Refer to: HSA-10/WZ-138

This is in response to your letter of November 20, 2002, requesting Federal Highway Administration (FHWA) acceptance of your company's portable breakaway sign stand, MDI Model 4884 as a crashworthy traffic control device for use in work zones on the National Highway System (NHS). Accompanying your letter was a drawing of the stand. You requested that we find this stand acceptable for use on the NHS under the provisions of National Cooperative Highway Research Program (NCHRP) Report 350 "Recommended Procedures for the Safety Performance Evaluation of Highway Features." You provided additional details at our request on January 30 and on February 21, 2003.

SCHEMATIC DRAWING

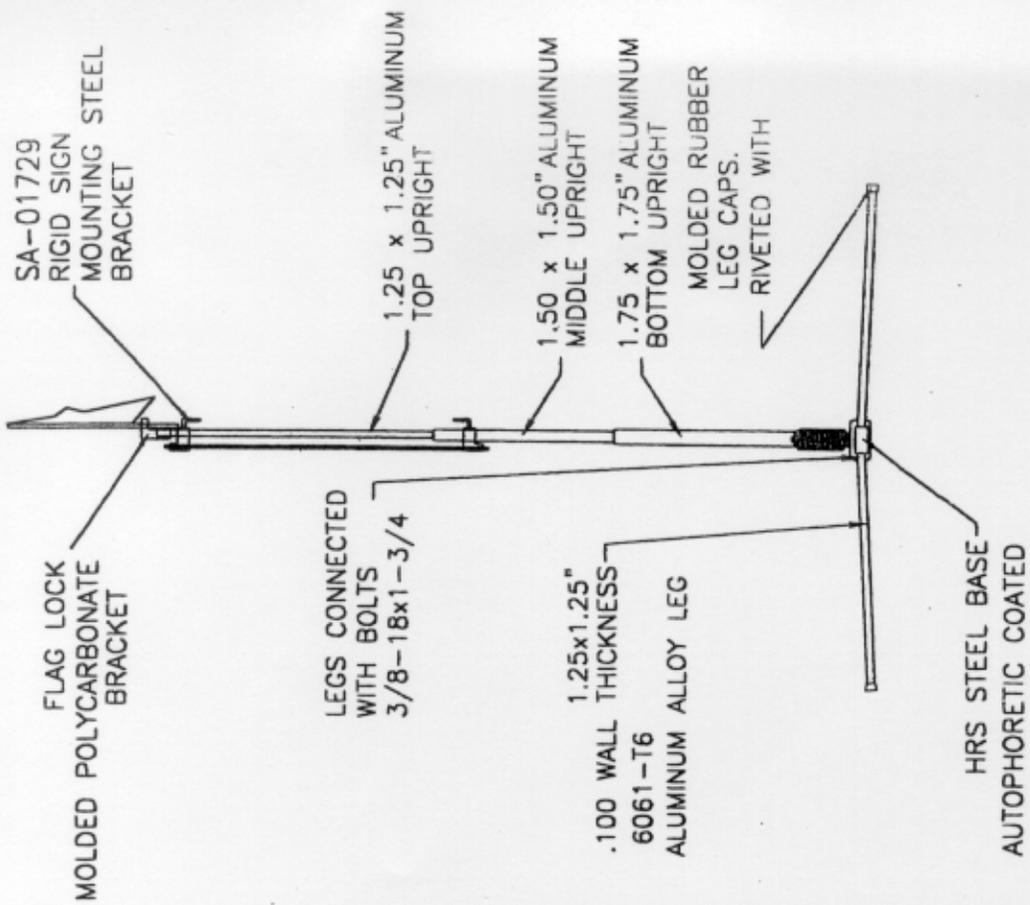
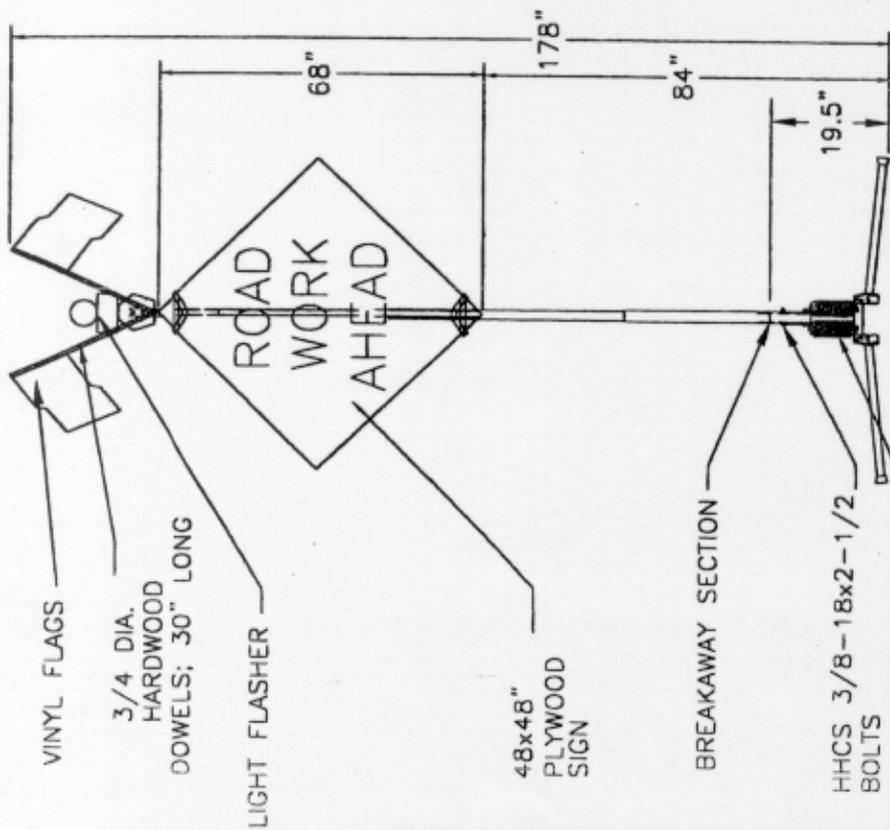
Your current request is for the **Model 4884** breakaway portable sign stand. The Model 4884 is identical in construction to the Model 4860 with the exception of the mast, which is in three parts. The bottom section of the Model 4884’s mast is 775 mm (30.5 inches) long of 44.5 mm (1.75 inch) square aluminum with a wall thickness of 2.54 mm (0.10 inch). The middle section is 865 mm (34 inches) long of 38.1 mm (1.50 inch) square aluminum with a wall thickness of 2.54 mm. The top section is 1725 mm (68 inches) long of 31.75 mm (1.25 inch) square aluminum with a wall thickness of 2.54 mm.

Full-scale automobile testing was conducted on the Model 4860 and was found acceptable. The Model 4884 is similarly constructed, includes the breakaway feature, and mounts the sign higher above the roadway. The only significant difference is the size of the lower mast, which is where the breakaway feature (external groove) is found. Because this could have a material effect on the breakaway performance of the stand, we asked you to conduct static tests to determine what forces were needed to activate the breakaway feature. When subjected to horizontal beam load tests, the 1 ½ inch specimen broke under a static beam load of 1480 pounds. The 1 ¾ inch specimen broke at a load of 1760 pounds. The difference of 280 pounds of force was less than a 20 percent increase. After reviewing the crash tests of the Model 4860 stand we conclude that any delay in the breakaway action of the larger mass would very likely be offset by the increased height of the sign and the sign and mass should still pass over the impacting vehicle. Therefore, the MDI Model 4884 breakaway portable sign stand described above and detailed in the enclosed drawing is acceptable for use on the NHS under the range of conditions that the Model 4860 was tested, when proposed by a State.
